**LONGHORN ARMY  
AMMUNITION PLANT**

**ADMINISTRATIVE  
RECORD**

**Response to Comments on  
Draft Technical Memorandum: Modeling Approach for Derivation of Soil and  
Groundwater Concentrations Protective of Surface Water and Sediment**

**Contract No. DACA56-94-D-0020, Delivery Order No. 0109  
Longhorn Army Ammunition Plant, Karnack, Texas**

FIGURE 1  
MODELING LOCATIONS  
LONGHORN ARMY AMMUNITION PLANT  
KARNACK, TEXAS

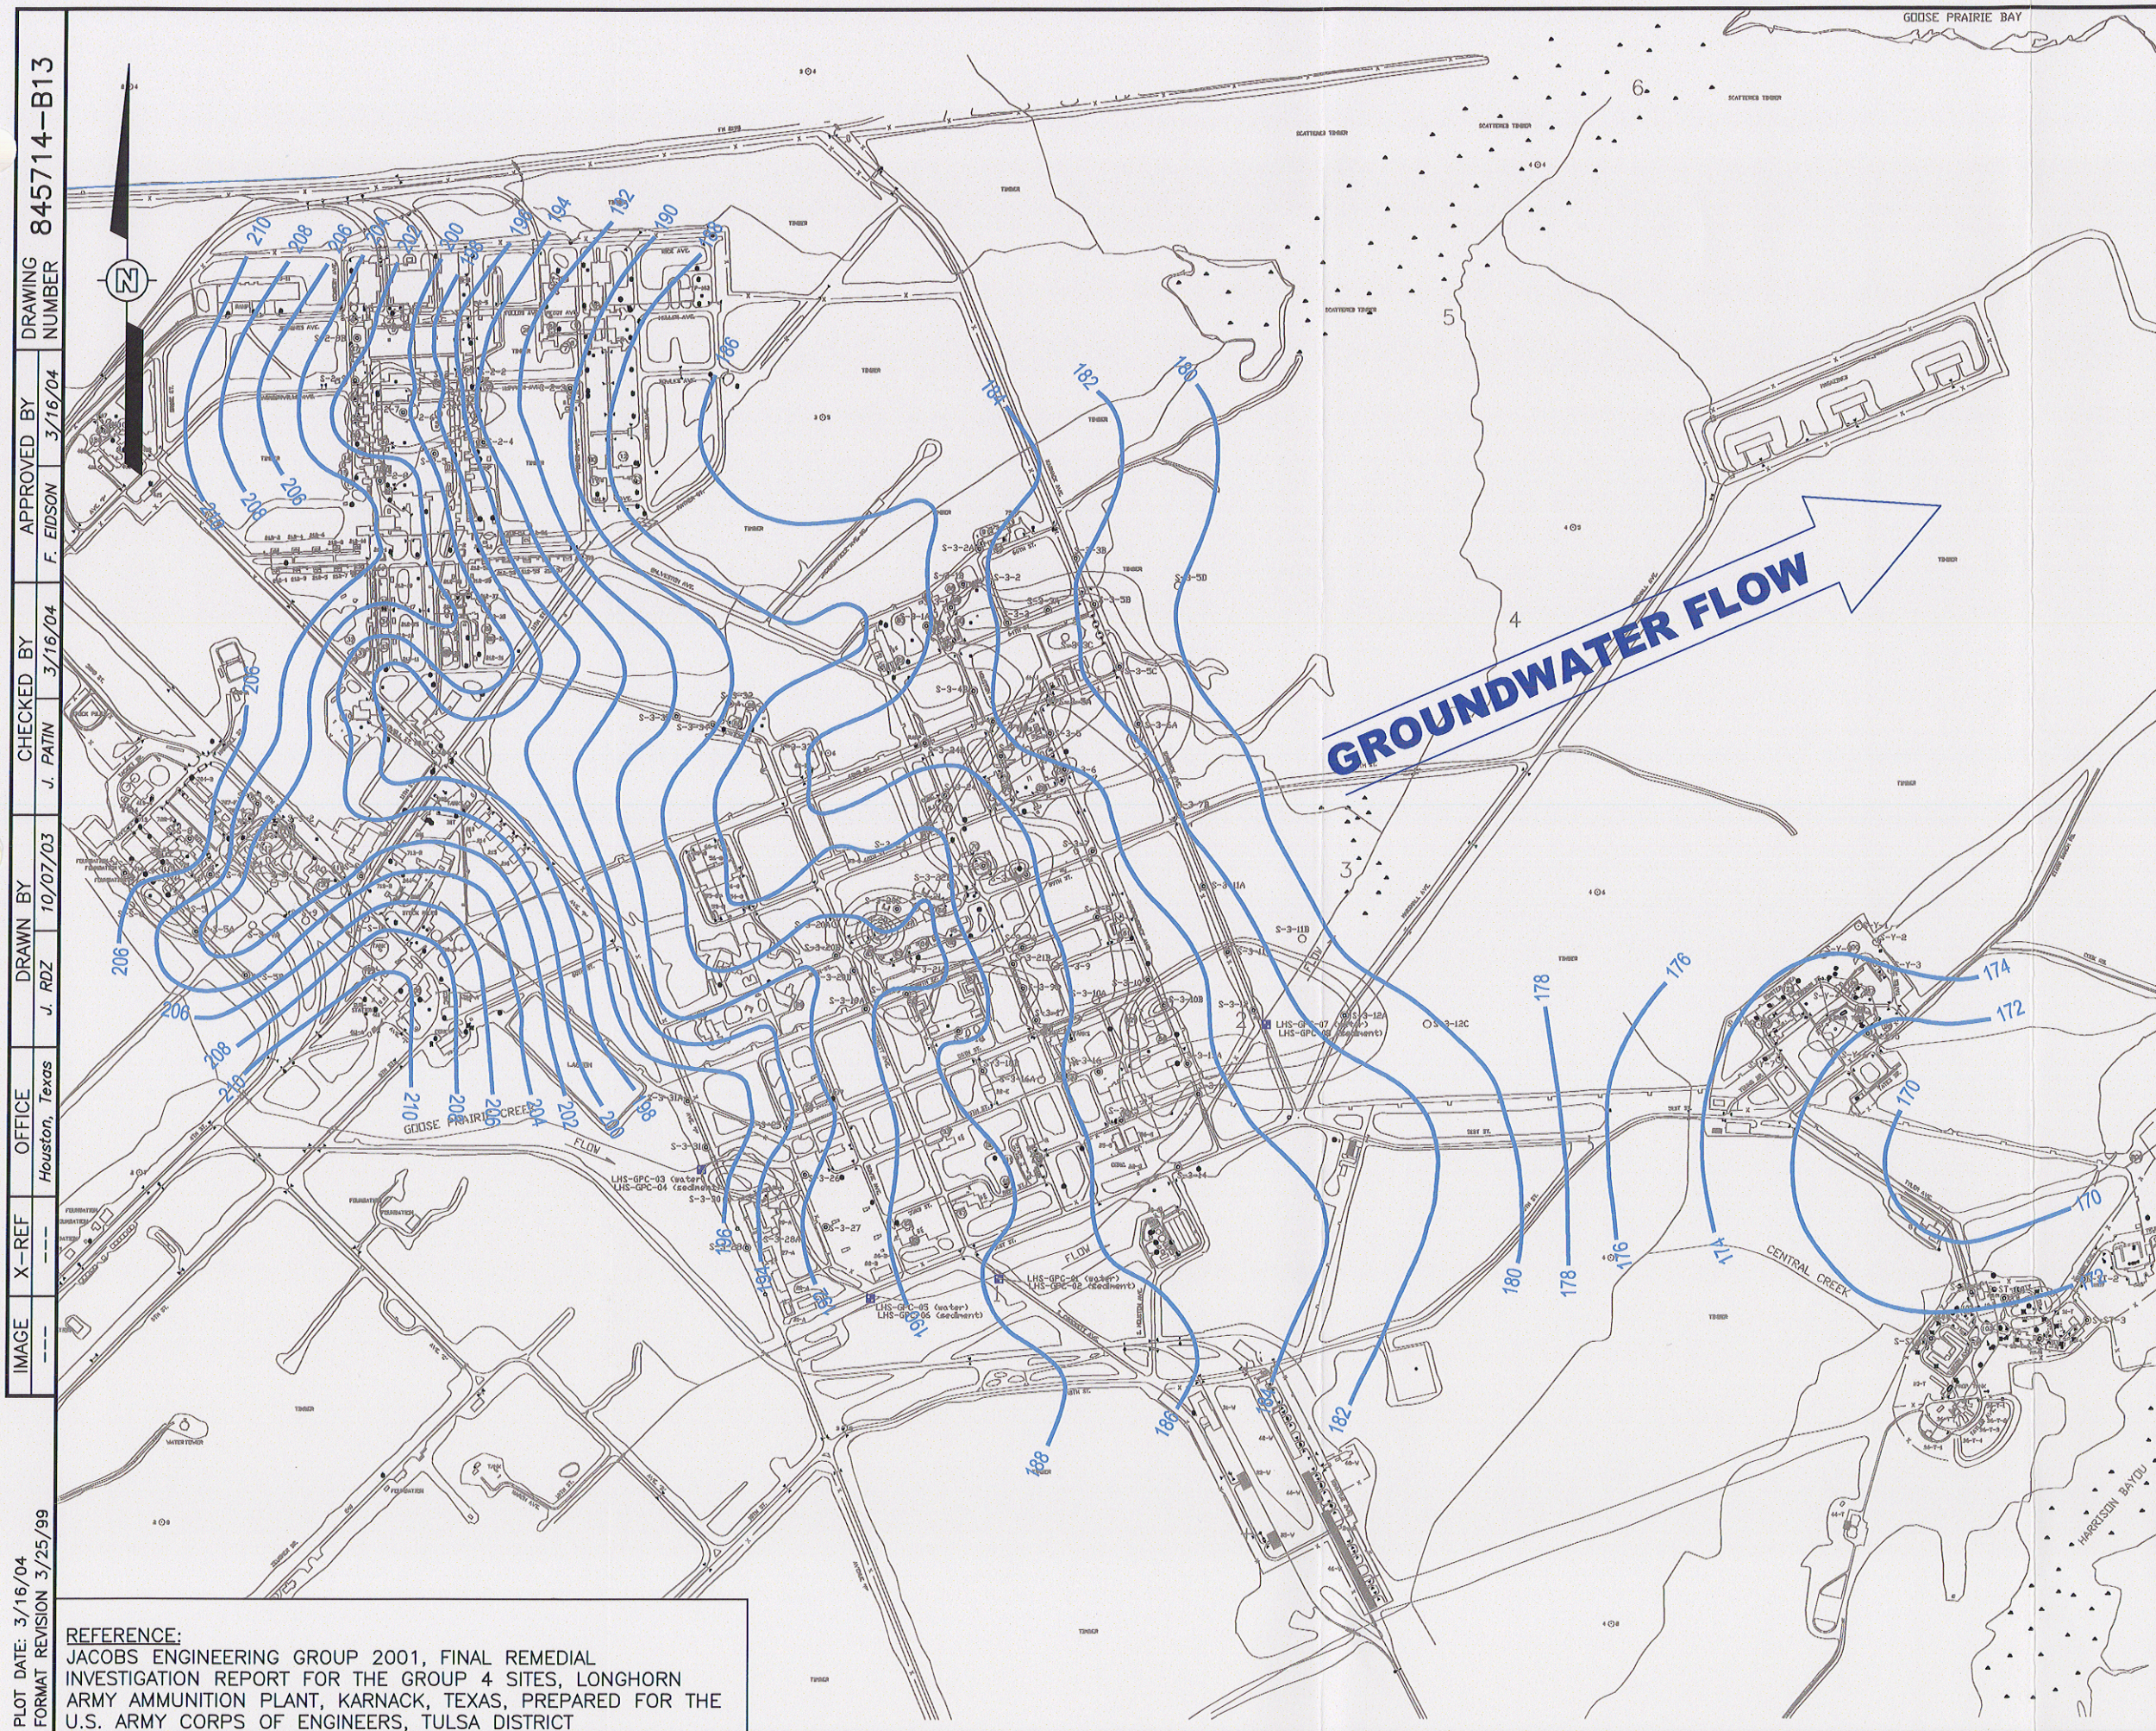
| Comment Number                      | Page(s)/Section | Paragraph/Line | Comment                                                                                                                                                                                                                                                                                                                                                                                                    | C, D, E <sup>1</sup> | Response                                                                                                                                                                                                                                                                                                                                                                                                                                                                             | A or D <sup>2</sup> |
|-------------------------------------|-----------------|----------------|------------------------------------------------------------------------------------------------------------------------------------------------------------------------------------------------------------------------------------------------------------------------------------------------------------------------------------------------------------------------------------------------------------|----------------------|--------------------------------------------------------------------------------------------------------------------------------------------------------------------------------------------------------------------------------------------------------------------------------------------------------------------------------------------------------------------------------------------------------------------------------------------------------------------------------------|---------------------|
| 10.                                 | Figure 1        |                | Suggest presenting the GW flow direction for the shallow/intermediate GWs                                                                                                                                                                                                                                                                                                                                  | C                    | Agree. Groundwater flow direction will be shown in a separate figure (Figure 2) of the revised memorandum.                                                                                                                                                                                                                                                                                                                                                                           |                     |

Figure 2

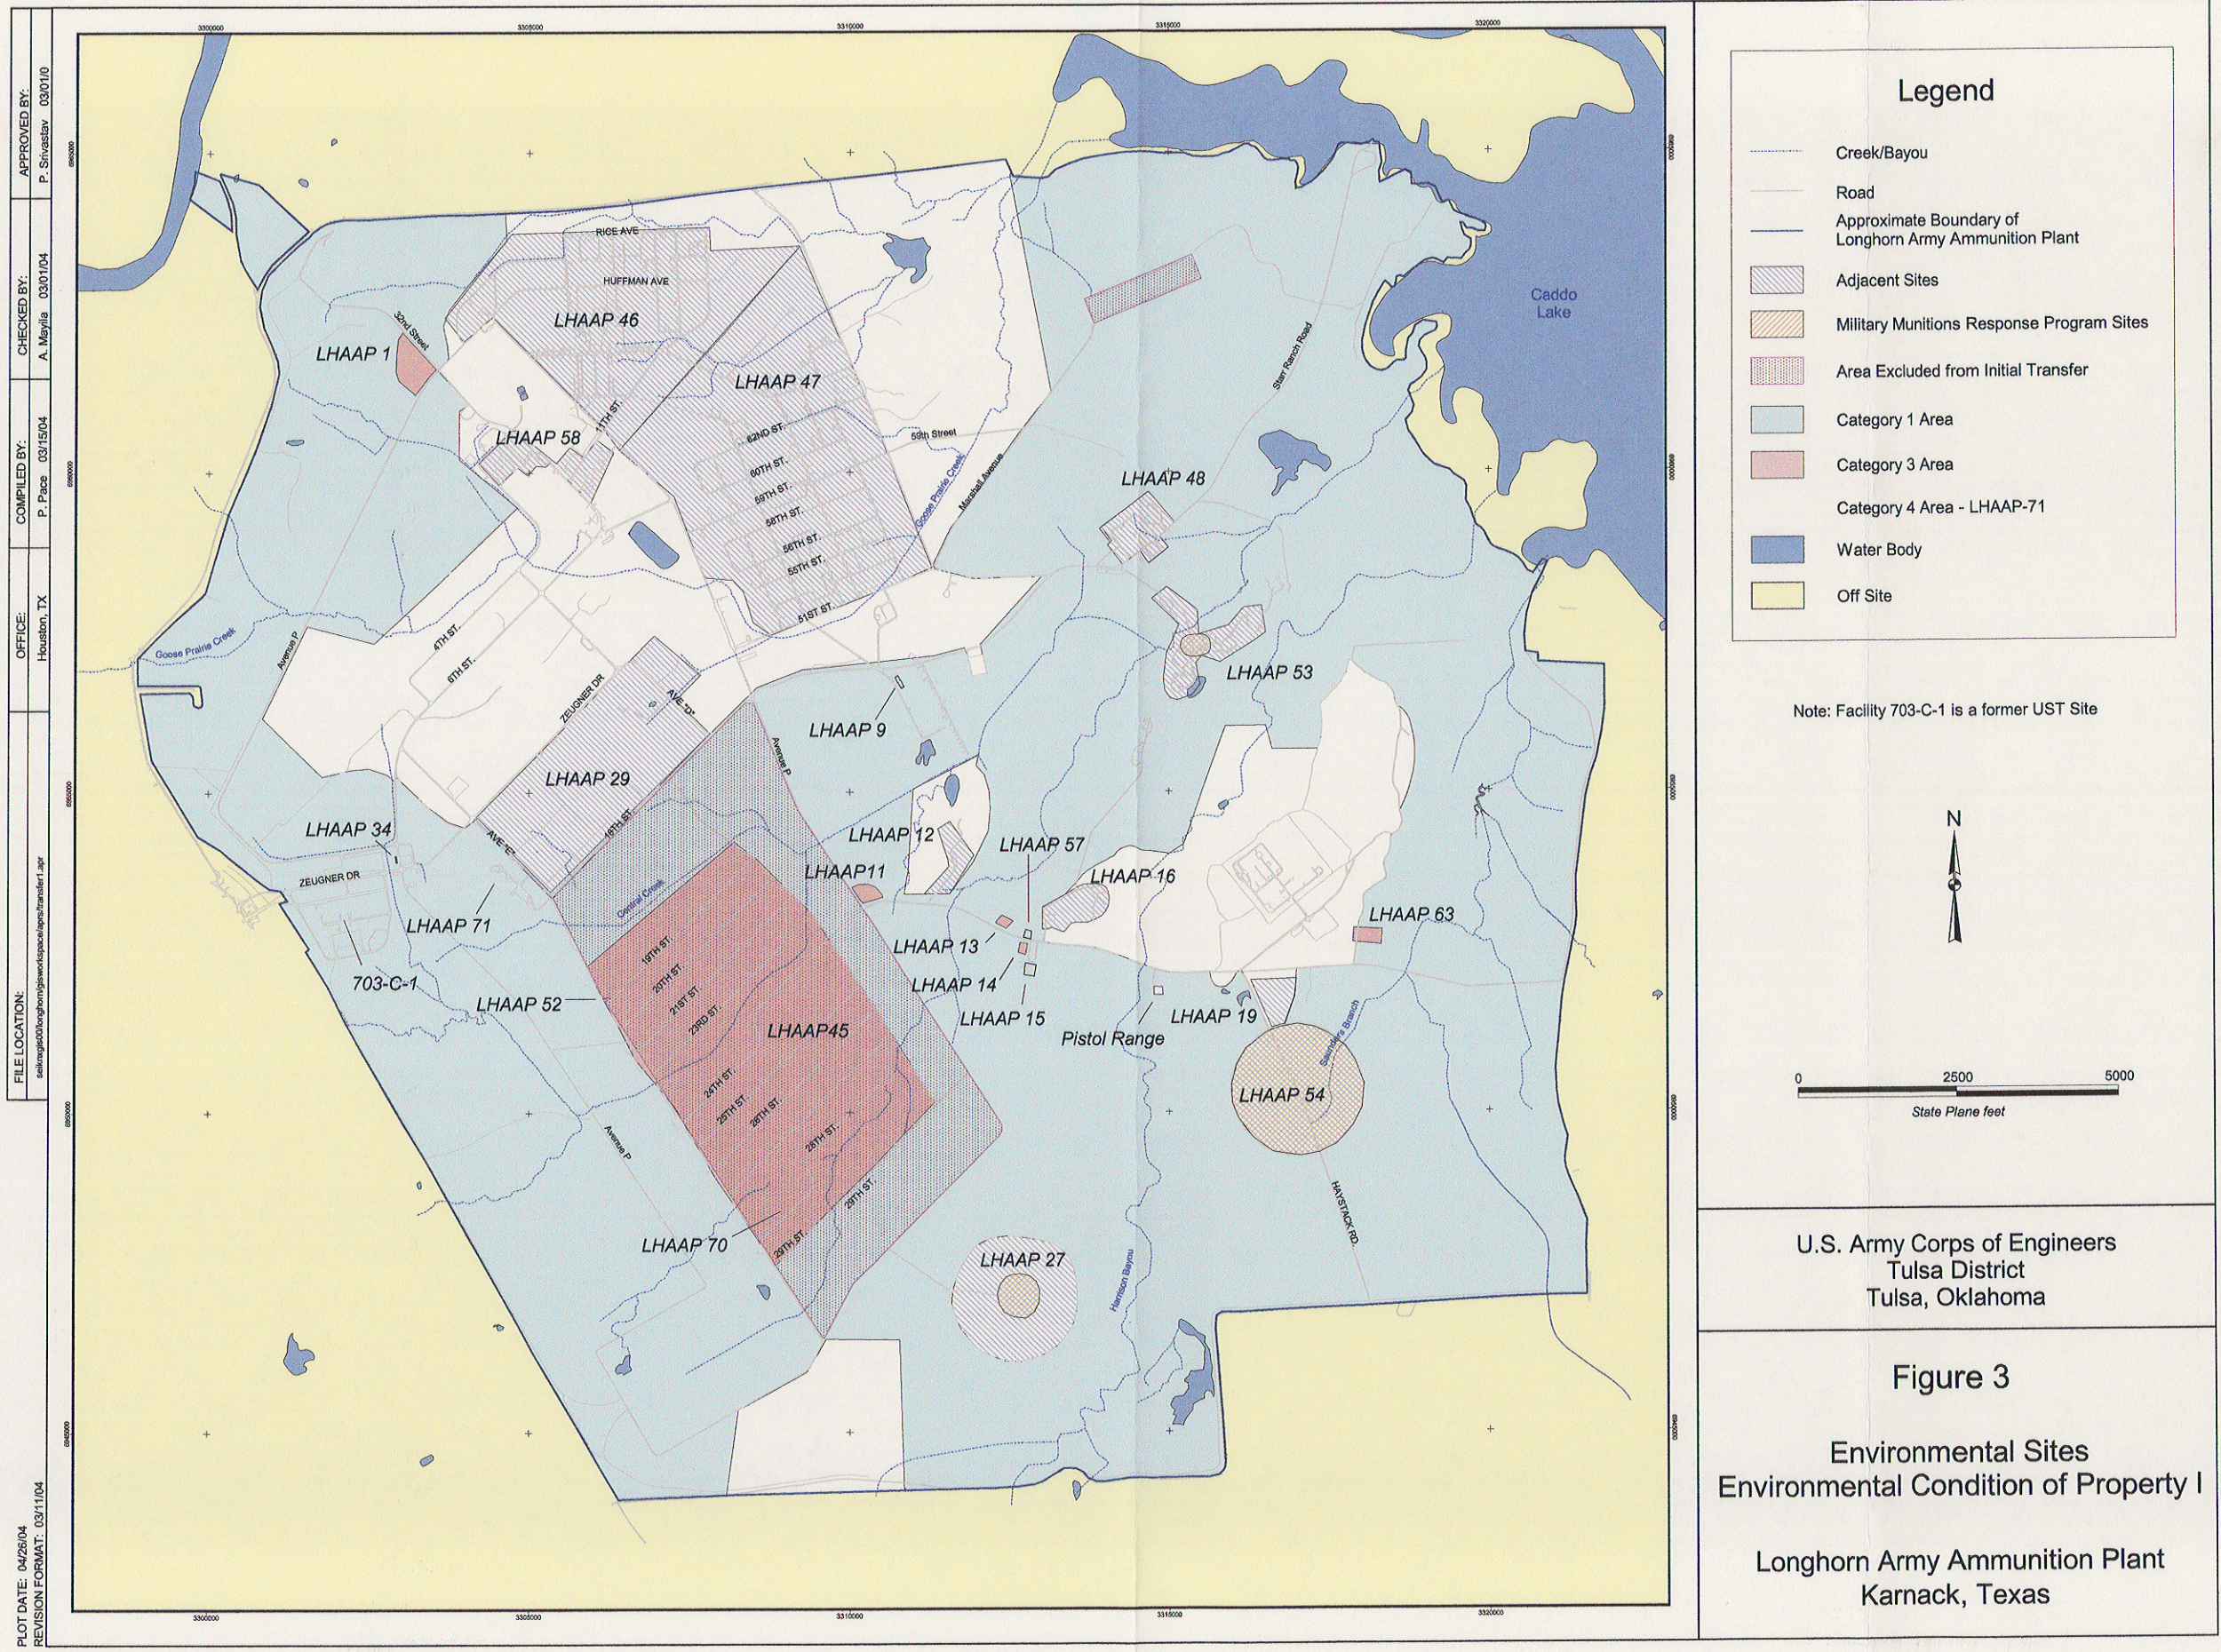
**Comment 1:** Section 2.0, Property Description: The text states "The Property proposed for transfer consists of approximately 5935 acres of land with 15 facilities as summarized in Table 1 and shown on Figure 2."

Will the final version indicate the exact number of acres to be included in the initial transfer? Also, Building 4-Y no longer exists and should be removed from Table 1 and Figure 2 and anywhere else that it is mentioned in the document; and the number should be reduced to 14.

The exact number of acres for the initial transfer to the USFWS is 5031.75 acres and will be included in the final ECOP document. It will also be noted in Section 3.1 that Warehouse Area and the Magazine Areas will not be included in the initial transfer to the USFWS. Building 4-Y will be removed from Table 1 and Figure 2 and the text will be revised to reflect the comment. Also, based on EPA Region 6 comments, transfer of LHAAP-45 (Magazine Area) and the Warehouse Area property will not be included in the initial transfer to the USFWS. It will also be noted in Table 1 and Figure 2, that Buildings 31-M and 35-M (associated with the Warehouse Area) will be not be included in the initial transfer to the USFWS.

The text in Section 2.0, last sentence will be revised as follows: "The Property proposed for transfer consists of approximately 5,935 acres of land with 14 facilities (however, the initial transfer to the USFWS consists of 5031.75 acres and 12 facilities) as summarized in Table 1 and shown on Figure 2.
